SUBJECT: Provides info that was requested in response to GL 95-07, "Pressure Locking & Thermal Binding of Safety-Related Power-Operated Valves."

Subject: Palo Verde Nuclear Generating Station (PVNGS)
Units 1, 2, and 3
Docket Nos. STN 50-528/529/530
Reponse to Generic Letter 95-07, Request
for Additional Information, dated June 11, 1999
(TAC NOS. M93497, M93498, M93499)

ENCLOSURE 1 RESPONSE TO GL 95-07 PRESSURE LOCKING AND THERMAL BINDING OF SAFETY-RELATED POWER-OPERATED GATE VALVES RAI

RESPONSE TO GENERIC LETTER 95-07, "PRESSURE LOCKING AND THERMAL BINDING OF SAFETY-RELATED POWER-OPERATED GATE VALVES," REQUEST FOR ADDITIONAL INFORMATION

Figure 1: Simplified Valve Gate, Bonnet, and Stem Pressure Locking Forces

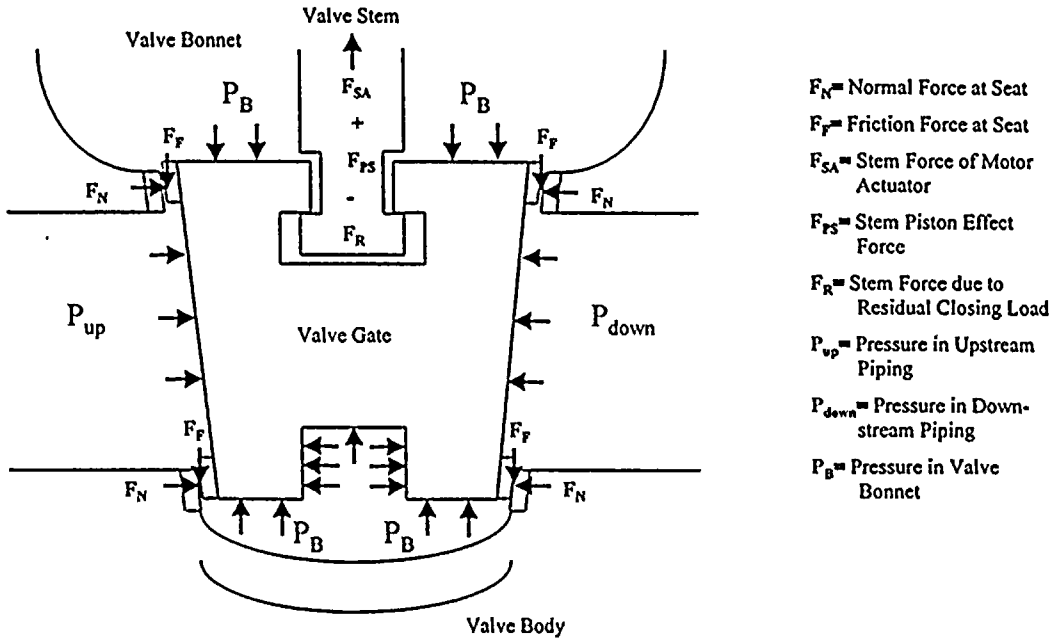
NRC QUESTION (1a):

Describe the pressure locking thrust prediction methodology and provide the test procedure/results that validate the methodology. Include any information that will help evaluate if your valves are similar to test valves as applicable.

APS RESPONSE (1a):

PVNGS PRESSURE LOCKING MODEL OVERVIEW

The PVNGS pressure locking thrust prediction methodology involves the superposition of five terms to determine the postulated state of pressure locking loading. Figure 1 represents a simplified pressure locking force diagram on the valve disk and stem. The resulting equation is:

Required Pressure Locking Stem Thrust (F_{total}) = Disk Load (F_{disk}) + Hub Load (F_{hub}) + Vertical Load (F_{vert}) + Residual Load (F_{resid}) – Stem Piston Load (F_{piston}).
